SUNDRY NOTICES AND REPORTS ON WELLS
Do not use this form for proposals to drill or to re-enter an abandoned well. Use form 3160-3 (APD) for such proposals.

1. Type of Well ☐ Oil Well ☒ Gas Well ☐ Other		8. Well Name and No. HORNSBY 35 FEDERAL COM 7H
2. Name of Operator CIMAREX ENERGY COMPANY OF CO Contact: DEYSI FAVELA E-Mail: dfavela@cimarex.com		9. API Well No. 30-015-42168-00-X1
3a. Address 600 NORTH MARIENFELD STREET SUITE 600 MIDLAND, TX 79701	3b. Phone No. (include area code) Ph: 432-620-1964	10. Field and Pool, or Exploratory WILDCAT
4. Location of Well (Footage, Sec., T., R., M., or Survey Description) Sec 35 T26S R27E Lot 2 0210FSL 2020FEL 32.000207 N Lat, 104.093151 W Lon		11. County or Parish, and State EDDY COUNTY, NM

Cimarex Energy respectfully requests changes to the APD:

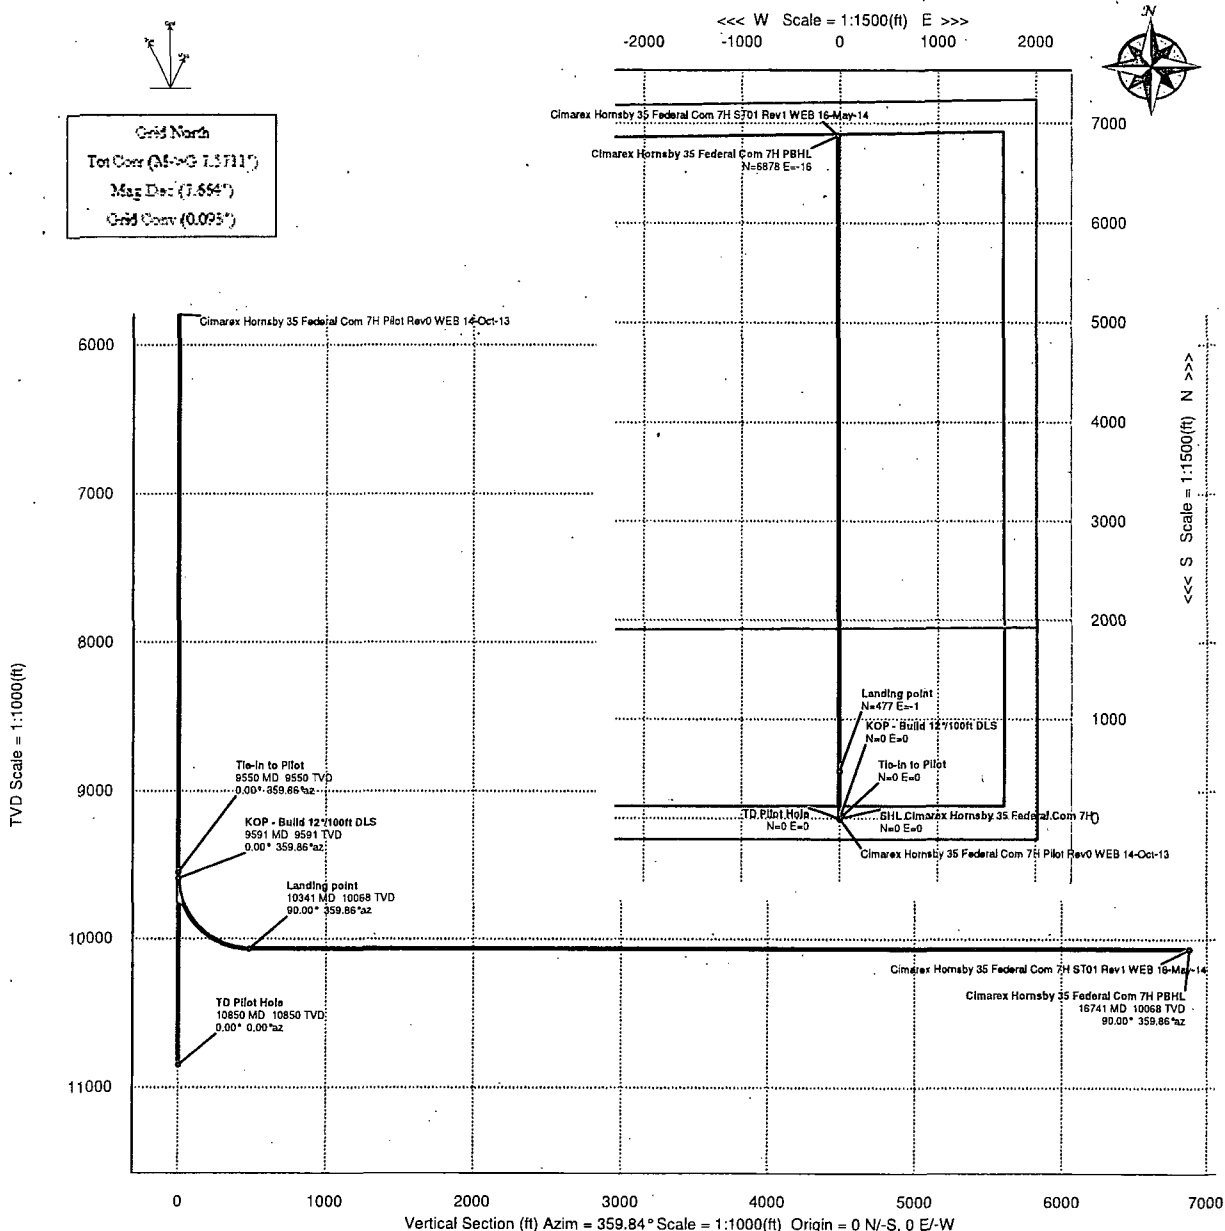
Proposed:

BHL 330' FNL & 2020' FEL

KOP 9591'

EOC 10341'

MD 16741'

TVD 10068'

PH 10850.(no change)

Pool Wolfcamp C Horizontal
